PART OF THE SOUTHEAST 1/4 OF SECTION 11, TOWNSHIP 15 SOUTH, RANGE 66
 WEST OF THE SIXTH PRINCIPAL MERIDIAN,
 COUNTY OF EL PASO, STATE OF COLORADO
MAJOR SITE DEVELOPMENT PLAN

2232 - EL PASO, COLORADO
 SECURITY BLVD. AND MAIN ST.
GRADING PLAN

MAJOR SITE DEVELOPMENT PLAN

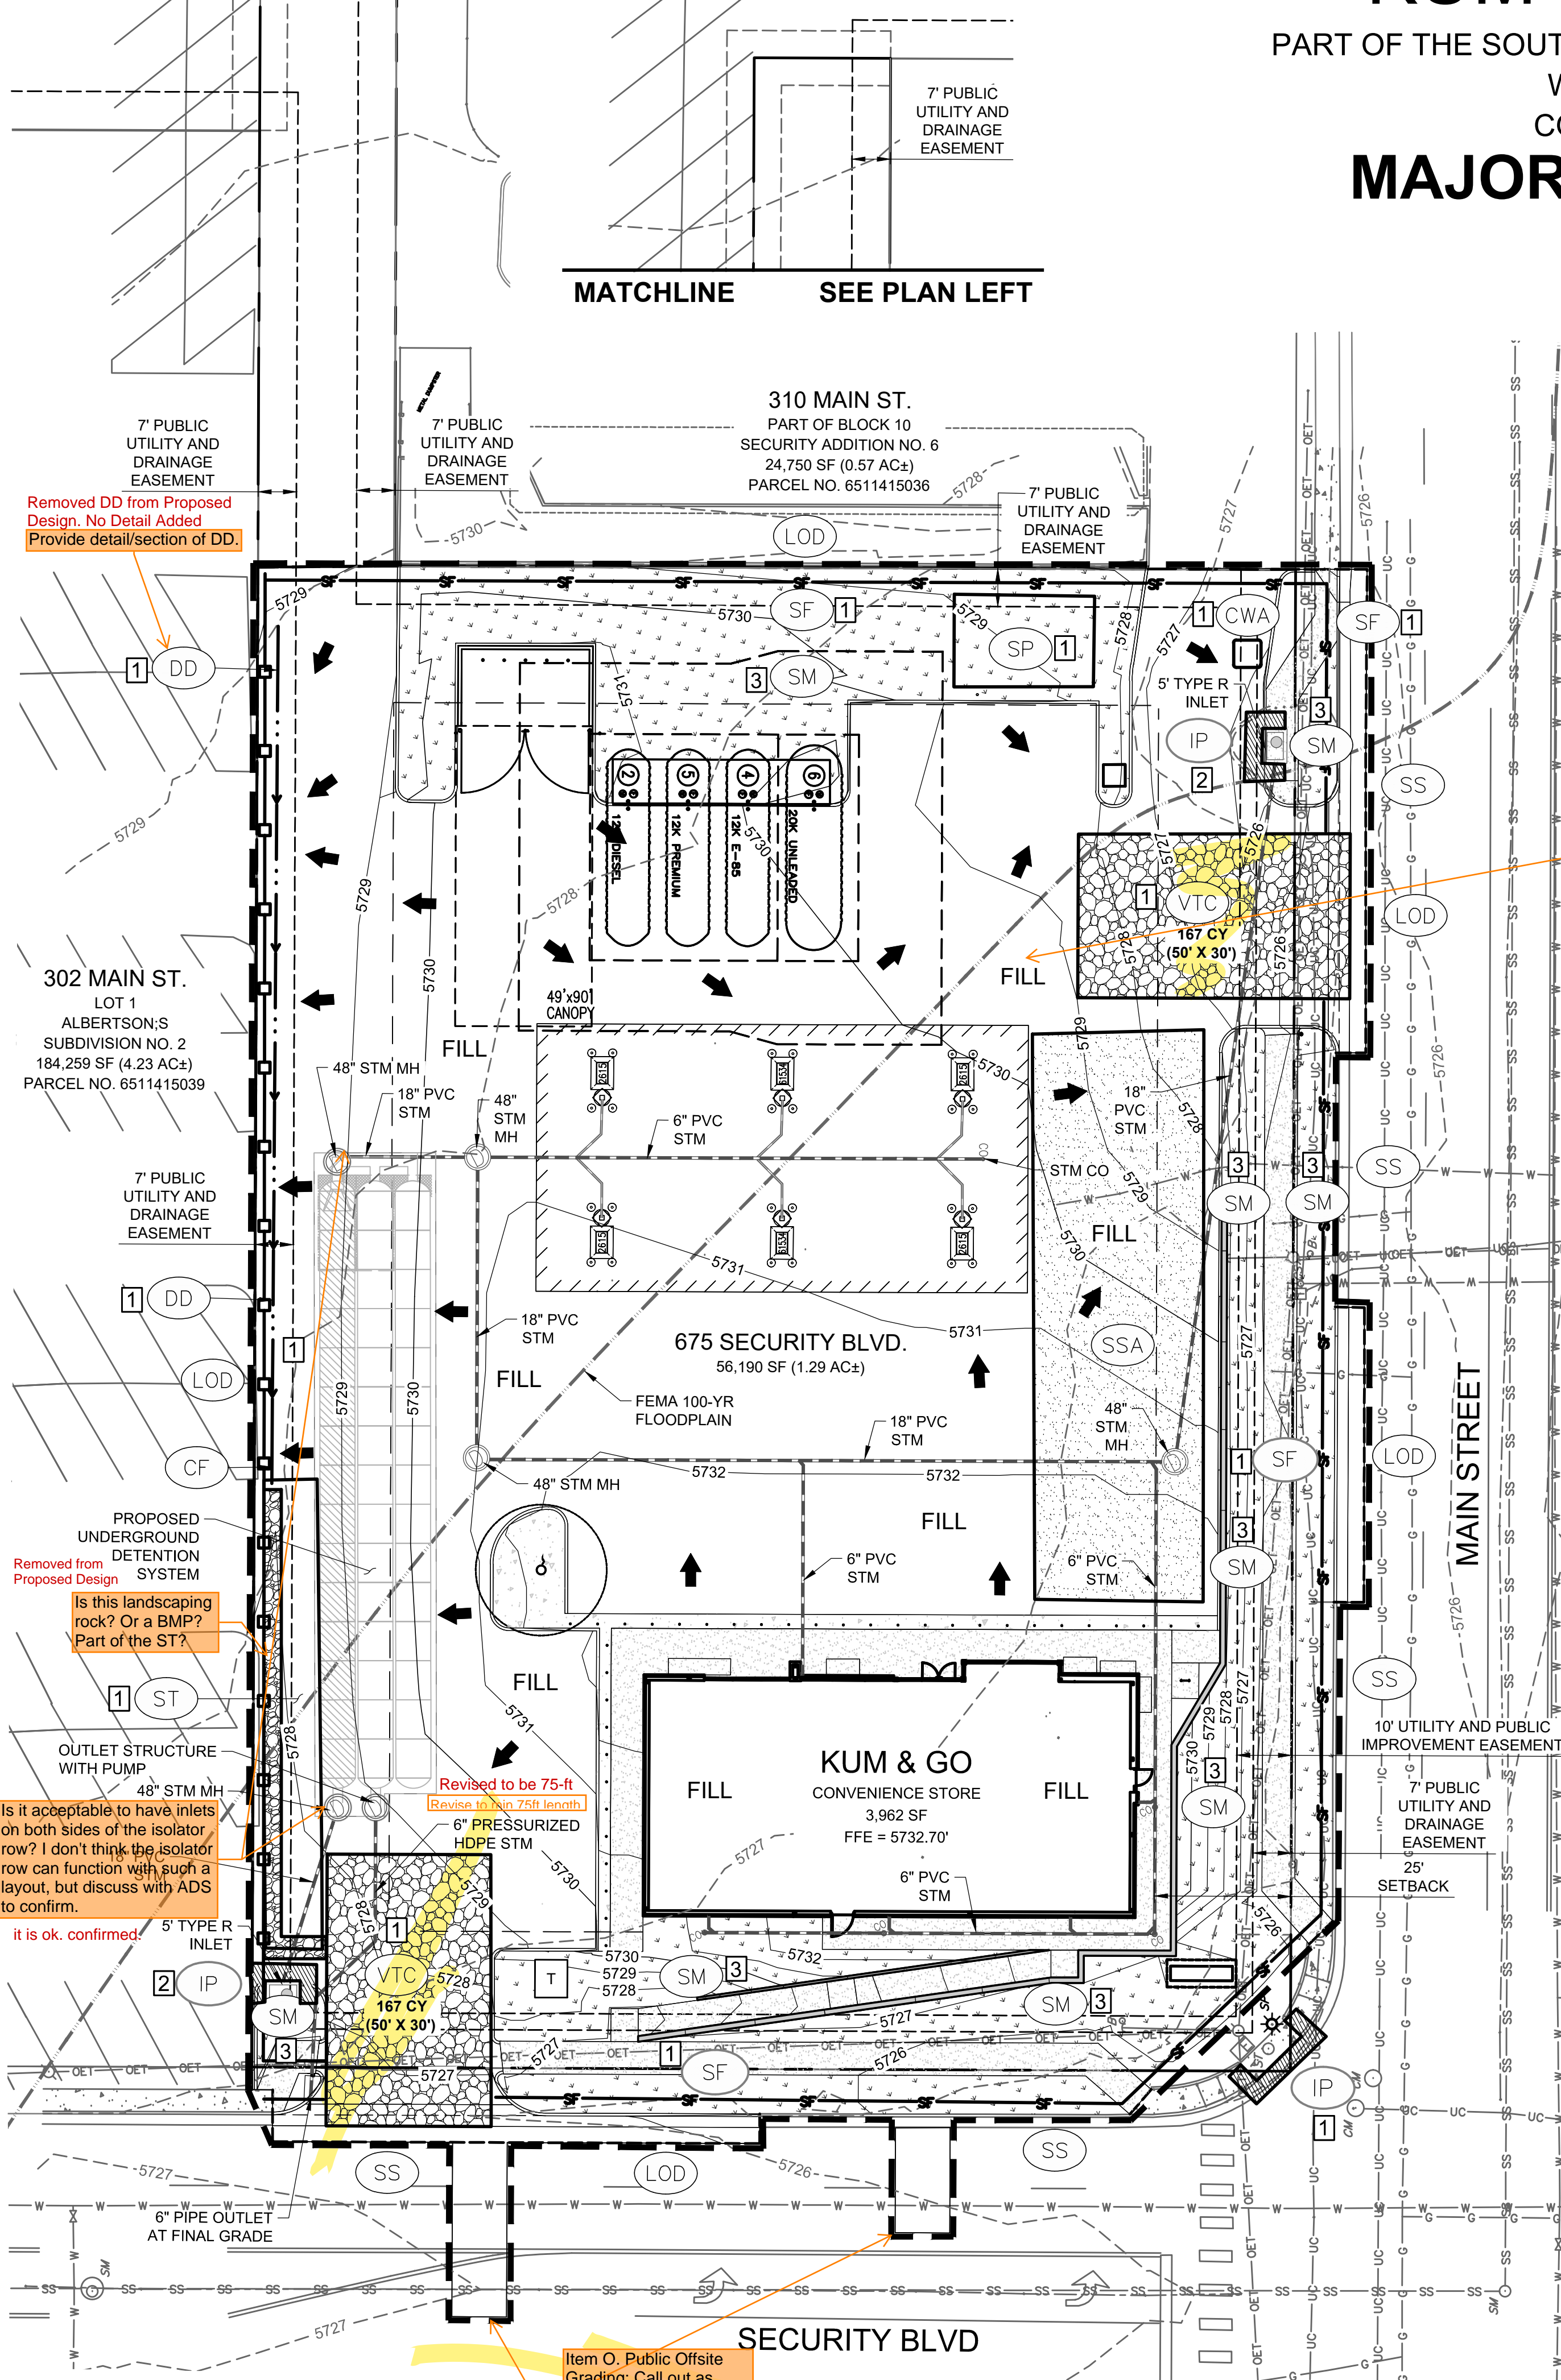
Item P - it is unclear where the areas of fill end and cut begins. Is the whole site fill? Delineate these areas with a linetype and/or note on this drawing that: "the site is mostly fill except cut in the following areas..."

Items H and M. If "limits of disturbance" and "construction boundary" are the same, change to "limits of construction/disturbance" or otherwise show as separate line types for each on the legend and figure.

Broke out Initial, Interim and Final Erosion and Stormwater Control Plans
Cleared all the clutter up and answered questions in review comments.
Added more FILL Labels, Interim and Final are clearer now for all the FILL
No Cut Area in The Site.

Vehicle Tracking Control (VTC) SM-4

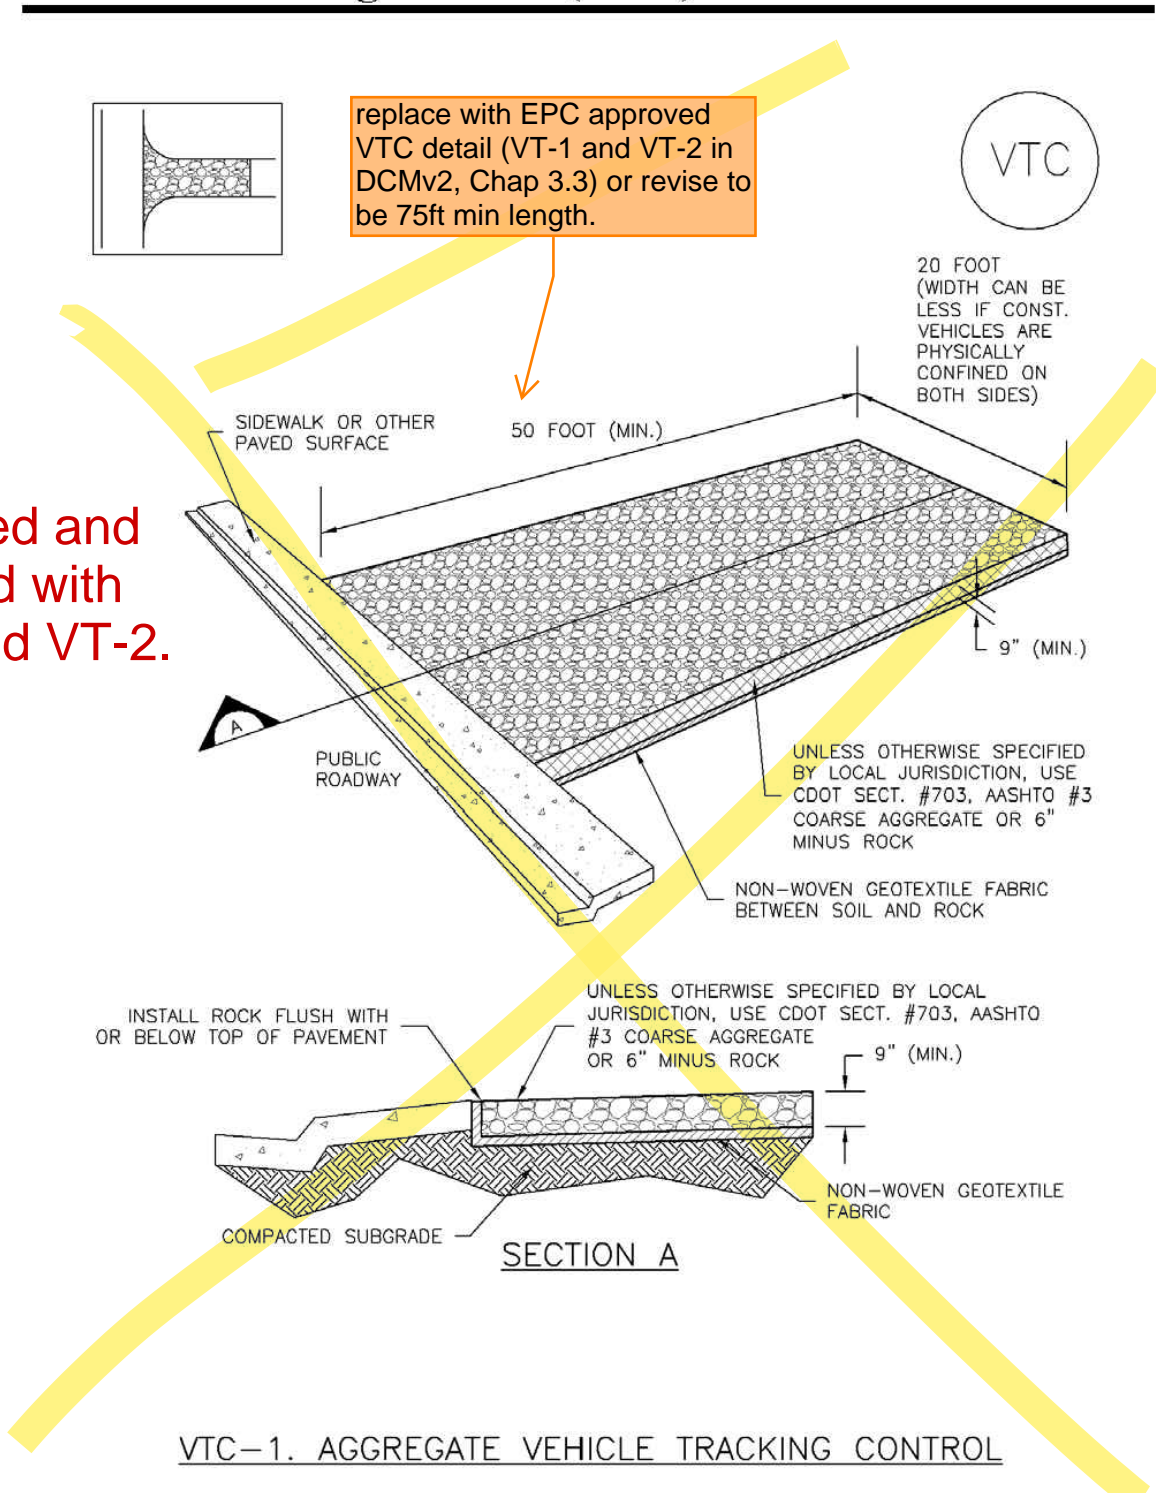
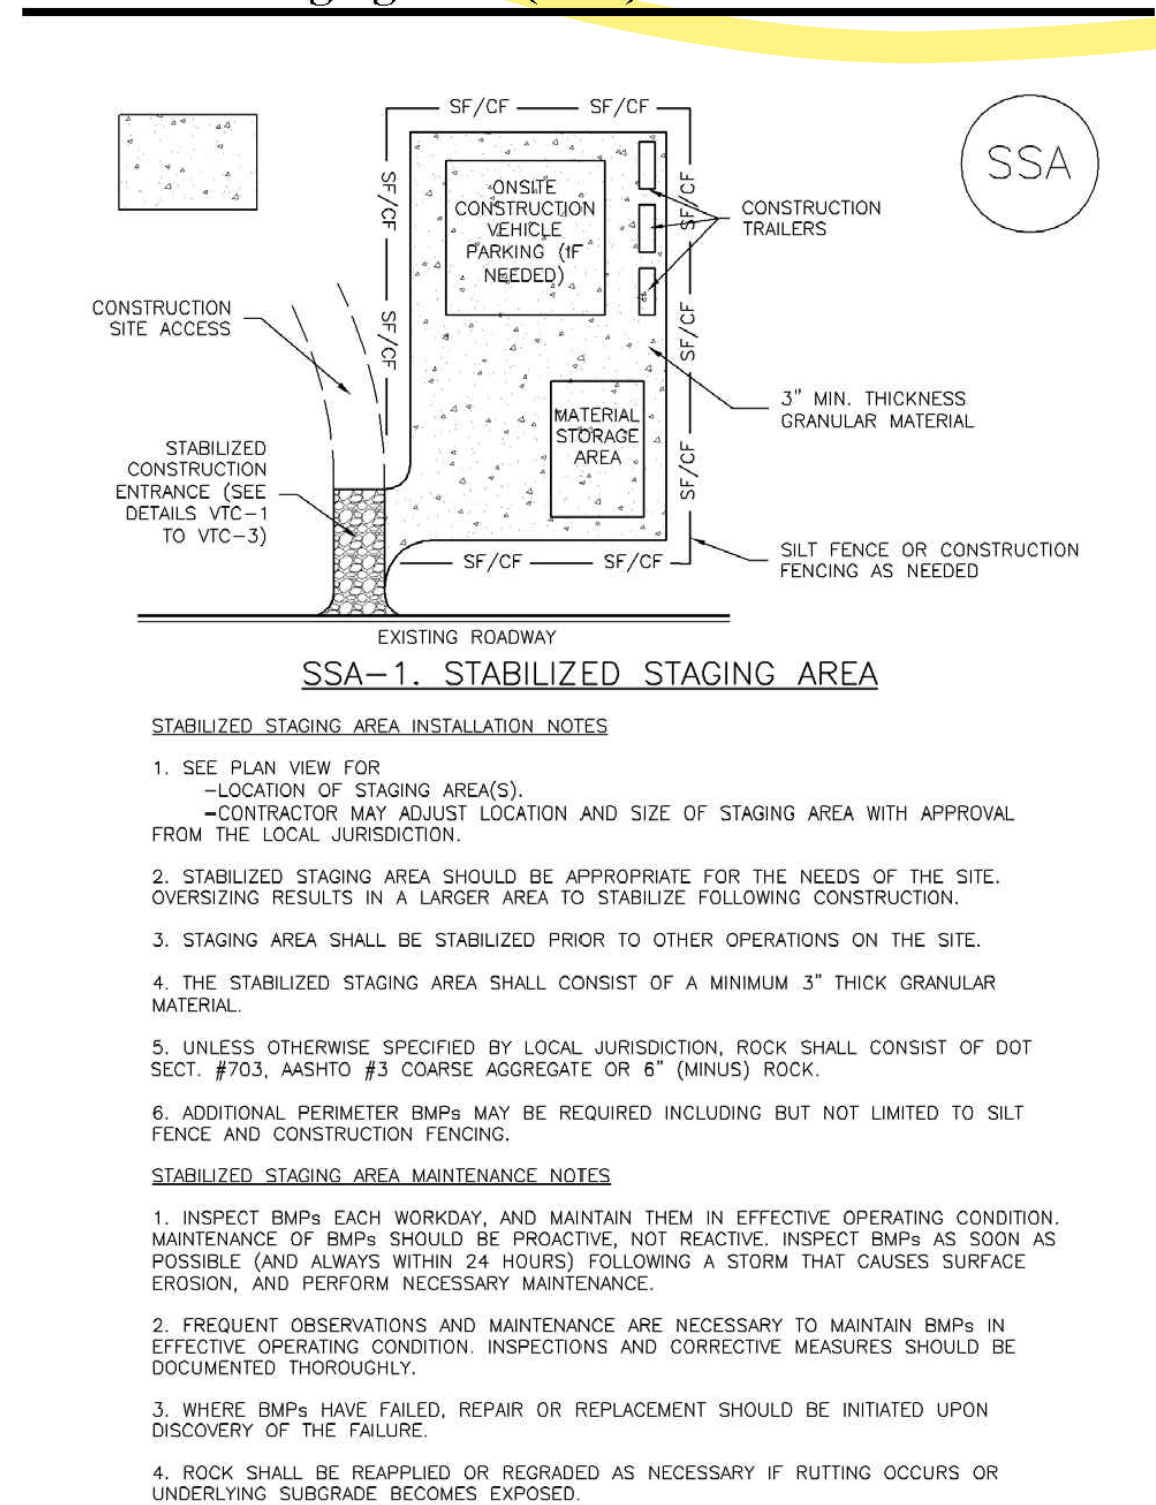
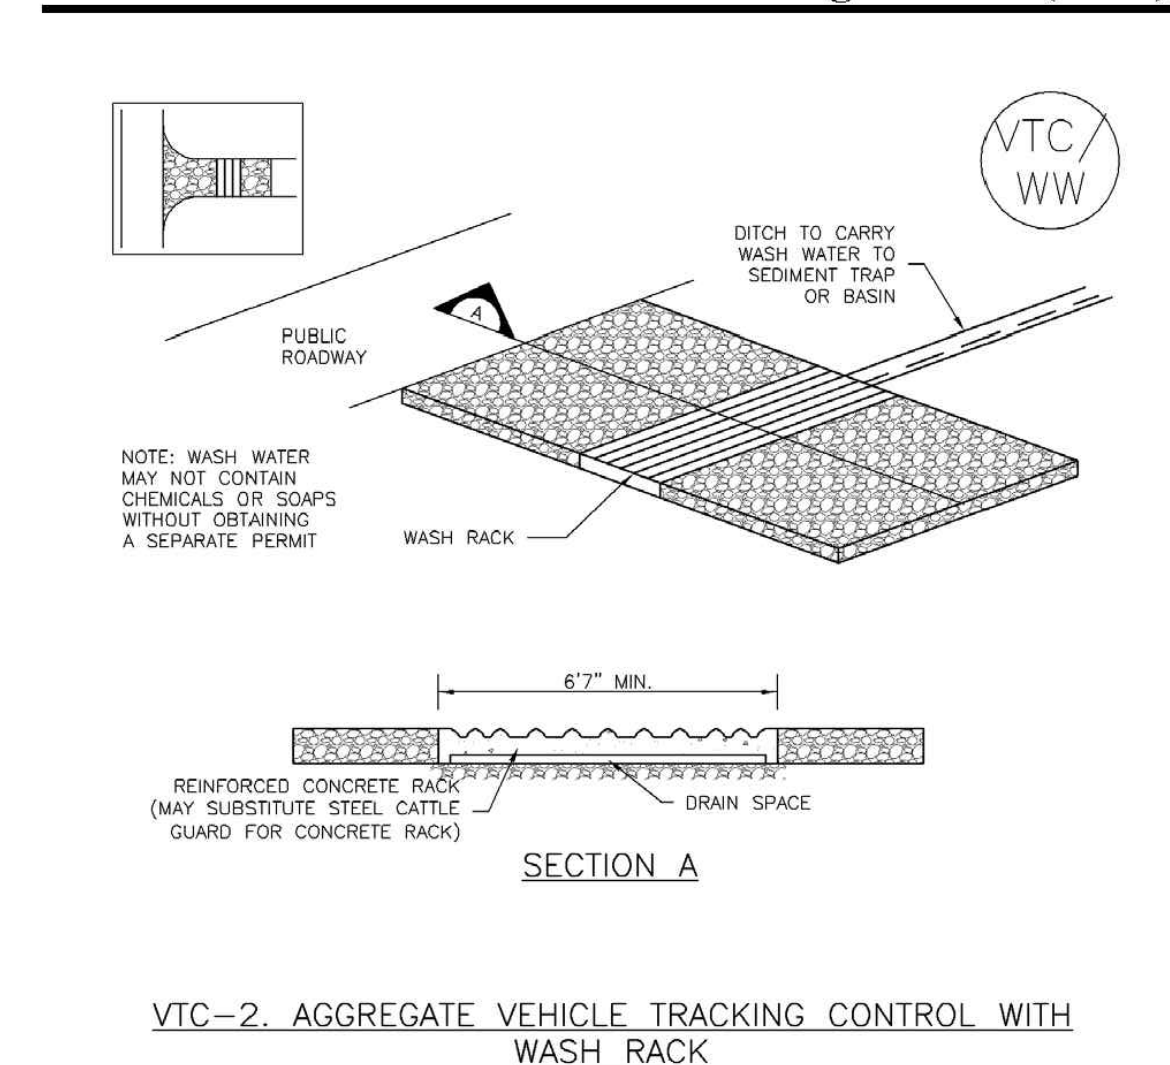
Please include construction notes as well. See attachment.

Added Notes to this sheet.

Took these two off the sheet and swapped them out with VTC5 and VTC6 from sheet 7 per review comment on sheet 7.
